METROPOLITAN GOVERNMENT OF NASHVILLE AND DAVIDSON COUNTY

STAFF RECOMMENDATION
1112 Lillian Street
February 19, 2014

Application: New construction - infill
District: Lockeland Springs-East End Neighborhood Conservation Zoning Overlay
Council District: 06
Map and Parcel Number: 08313013500
Applicant: Jeff Zeitlin, Martin Construction
Project Lead: Sean Alexander, sean.alexander@nashville.gov

1112 & 1114 Lillian Street Infill Project
Floor Plans

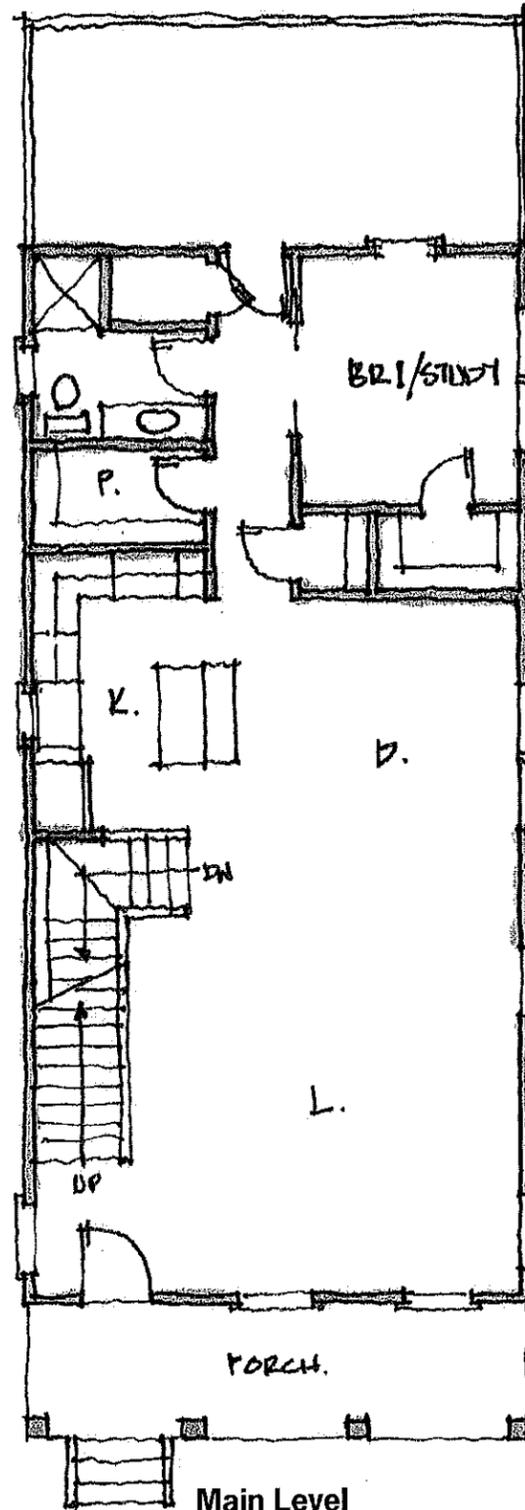
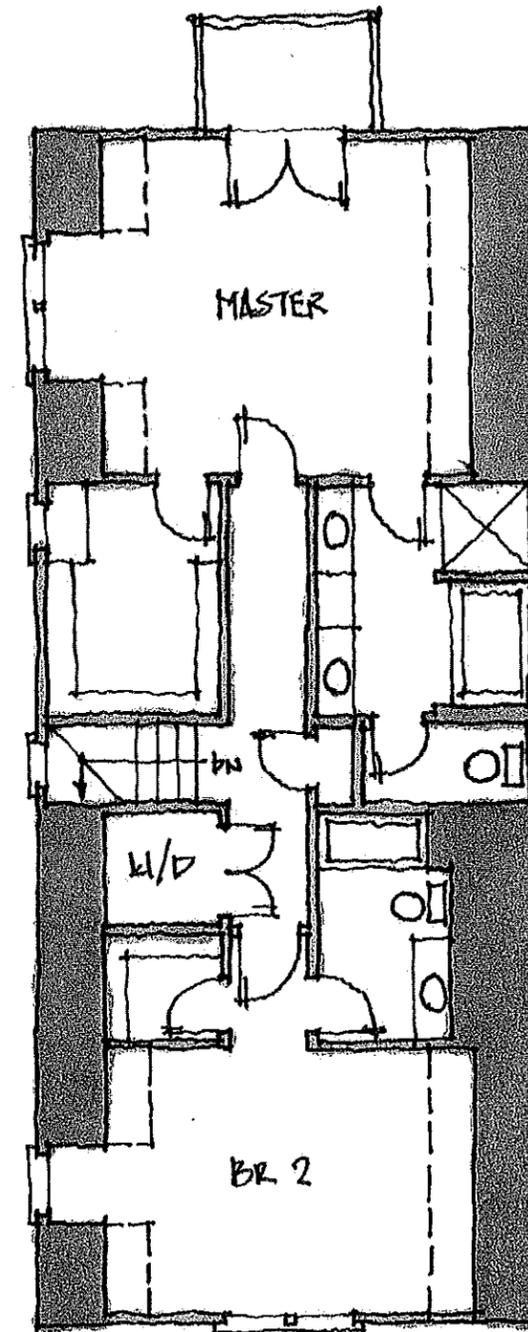
The new building will be one and one-half stories with a maximum roof height of twenty-nine feet (29') above grade with eaves at fifteen feet (15'). There will be one foot (1') of foundation exposed and a one foot (1') water-table band between the foundation and the finished floor level. Due to a drop in grade, the structure will gain an additional story in the basement level at the rear. The plans show the basement-level as having a bedroom, a bathroom, and a two-car garage.

The location of the HVAC and other utilities was not indicated on the drawings. The HVAC should be located on the rear façade or on a side façade beyond the midpoint of the house in order to meet section II.B.9.

1112 & 1114 Lillian Street Infill Project
Front Elevation and Right Side Elevation

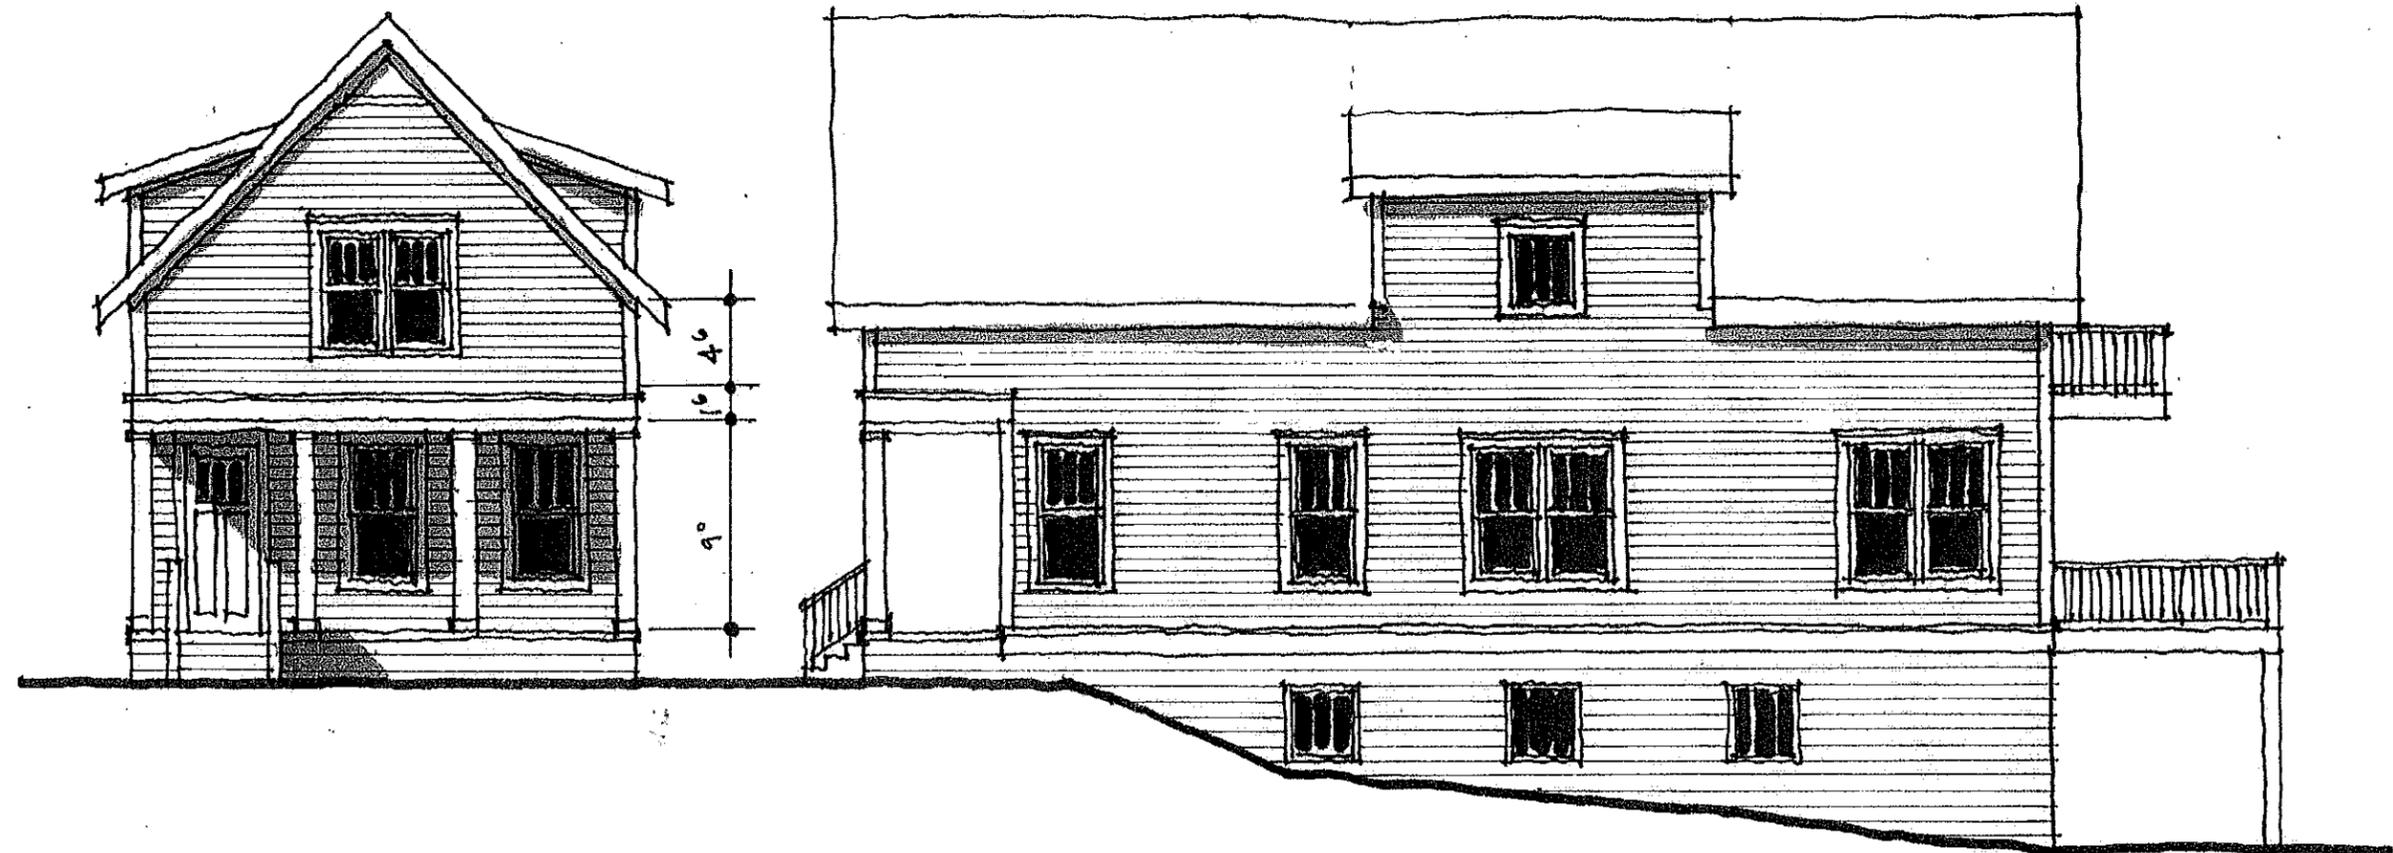
The exterior materials will include a split-faced concrete block foundation, smooth-faced cement-fiber siding with a five inch (5") reveal, and a gray asphalt single roof. The

The roof will be a front-facing gable with a 12:12 pitch. There will be shed-roofed wall dormers on each side of the roof with a pitch of 4:12. Wall dormers are not common features on historic houses nearby, but because the width of the lot forces the house to be narrower than other houses nearby, setting dormers in would not be feasible. Staff finds that the proposal meets guideline II.B.5.

1112 & 1114 Lillian Street Infill Project
Rear Elevation and Left Side Elevation

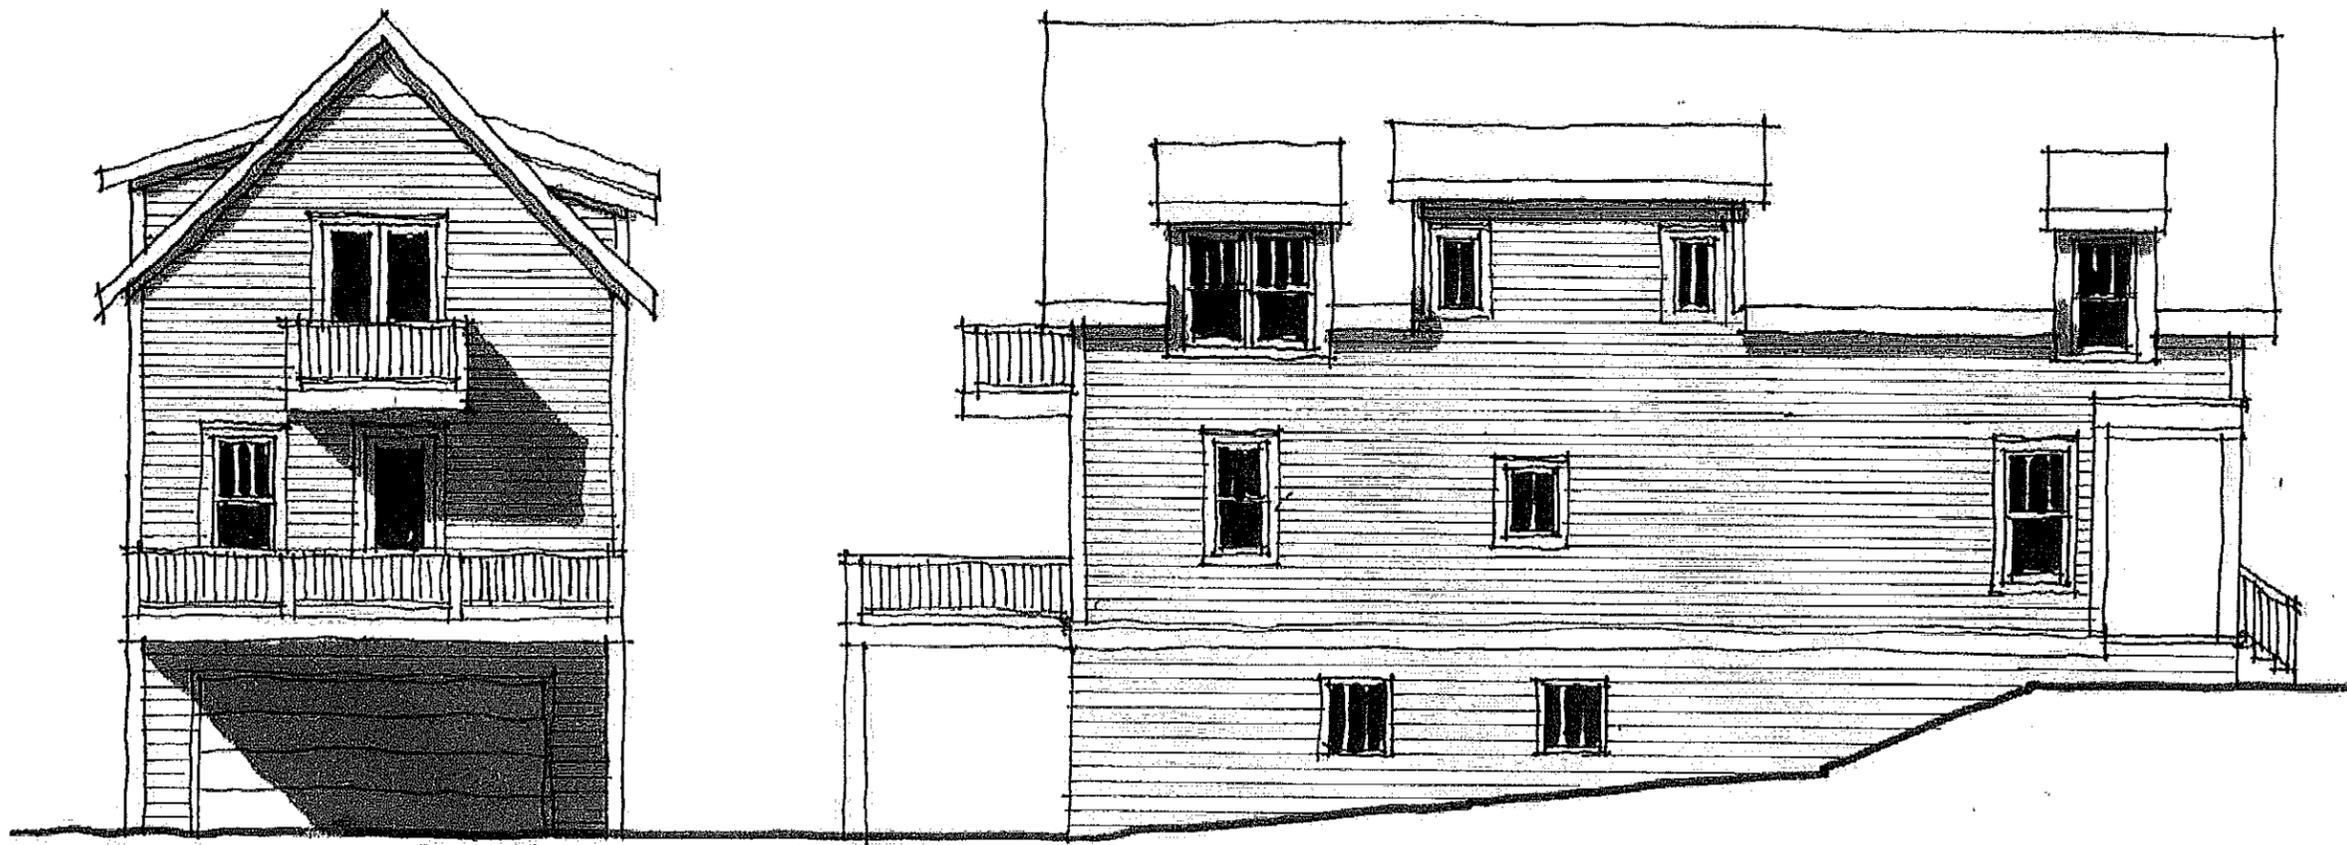
The windows on the house will be generally twice as tall as they are wide, and the first story windows will be taller than those on the upperstory. With the exception of a section on wall on the left side, there will be no expanse greater than ten feet (10') without an opening. Typically, historic houses have a no more than eight to twelve feet (8' – 12') of wallspace between window openings. Staff finds that with the addition of a window on the left side of the house, the proposal will meet guideline II.B.7.

- A window is added to the left side of the building;
- That the drawings are revised to call out dimensions and materials.
